Accessory Parts FMVSS Noncompliance Recall

17258 Front Head Restraint Removable After Tablet Holder Installed

Reference Number: N172095270

Release Date: August 2017
Revision: 00

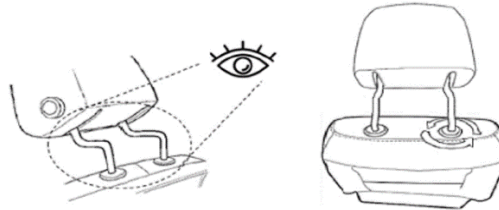
Lower the seat back rearward to gain space between the head restraint and the roof. Ensure that the headrest cushion is locked in place on the posts and will not move and then, pulling vertically on the head restraint assembly, attempt to remove the head restraint from the seat back. **If the head restraint will not come out of the seatback, no further action is required.** Please retain the included instruction sheet below for your records in case you should ever wish to remove the universal tablet holder and reinstall it.

If the head restraint assembly can be removed, refer to the revised instruction sheet on the next page to properly re-install your accessory. If for any reason, you cannot complete the instructions properly take your vehicle to the dealer to have the tablet holder installation corrected.

Buick Envision Universal Tablet Holder Installation Instructions

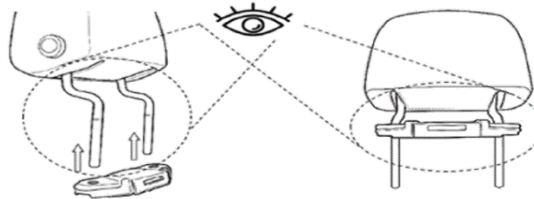
The original instruction sheet included for installation of the Universal Tablet Holder provides special requirements for the Buick Envision, which involve removing the button caps at the base of the seat post, but another area of the instruction sheet lists the Envision as a model that does not require this step. If the Envision button caps were not removed during installation, the head restraints will not fully engage into the seat back.

1. - Remove the button caps on the headrest posts to remove the headrest per vehicle procedure.
- Déposer les capuchons à bouton des montants d'appui-tête, afin de déposer l'appui-tête conformément à la procédure du véhicule.
- Retire las tapas de plástico en los postes de la cabecera para quitar la cabecera de acuerdo al procedimiento del vehículo.

3. - Install headrest with the tablet holder. Do not install the button caps, store them in safe place (like glove box) in case they are needed in the future.
- Installer l'appui-tête avec le support de tablette. Ne pas installer les capuchons à bouton. Les conserver en lieu sûr (dans la boîte à gants, par exemple), pour le cas où ils seraient utiles.
- Instale la cabecera con el soporte de tableta. No instale las tapas de plástico en los postes de la cabecera, guárdelas en un lugar seguro (como en la guantera) en caso de que se necesiten en el futuro.
